CITY OF ALBUQUERQUE

RE: **Lot 30 Block 1 Volcano Cliffs Unit 22 SAD 228**
8019 Canoncito Dr. NW
Grading and Drainage Plan
Engineers Stamp Date 4/18/2024 (D10D003N30)
Pad Certification Date 6/3/2025

HYDROLOGY SECTION

LOT 30, BLOCK VOLCANO CLIFFS SUBDIVISION UNIT 22
CITY OF ALBUQUERQUE, BERNALILLO COUNTY, NEW MEXICO

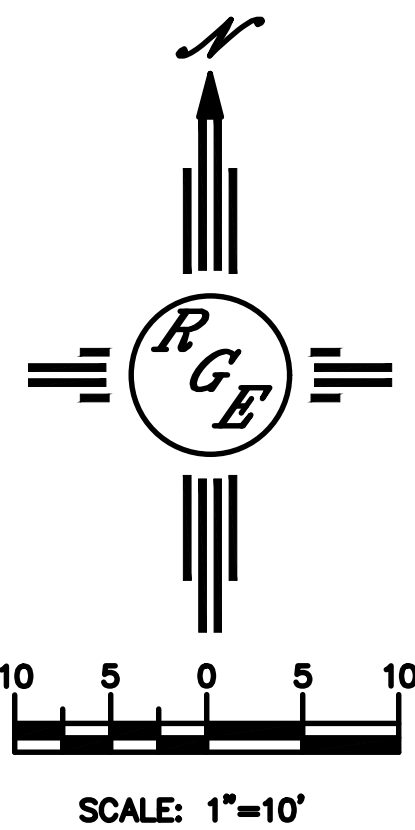
Based upon the information provided in your submittal received 6/10/2025, this plan is approved for building permit.

Reiterate to the Owner/Contractor that a separate permit for a garden/retaining wall must be obtained, with the approved G&D plan and Pad Certification. Advise the owner & Contractor that dirt is not allowed in the public right of way to climb the curb. Crusher fines or lumber is allowed. If dirt is used this will delay going forward with the construction of the home.

Prior to Certificate of Occupancy release, Engineer Certification per the DPM checklist of this plan will be required.
